ADDENDUM NO. 2

Issued by: Sacramento City Unified School District

Project: **Project #: 460-1**
Cesar Chavez / Edward Kemble Elementary School Furniture

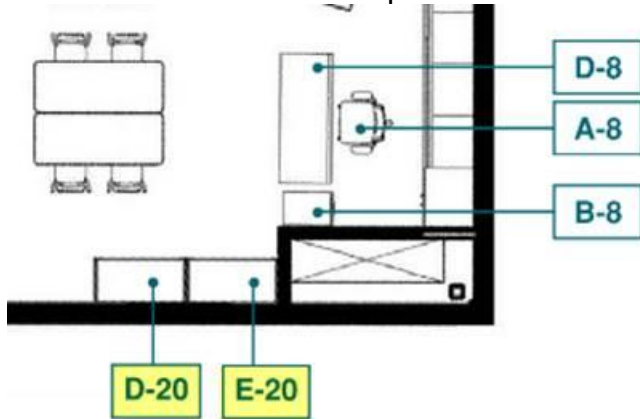
Question #16: There are a total of 6 collaboration spaces on the campus drawing. The drawing shows a quantity of five for item C-15 (only two items are called out, the other three are assumed). Please confirm the district intends to install five backpack carts in each collaboration space.

Response #16: 5 backpack carts per collaboration space
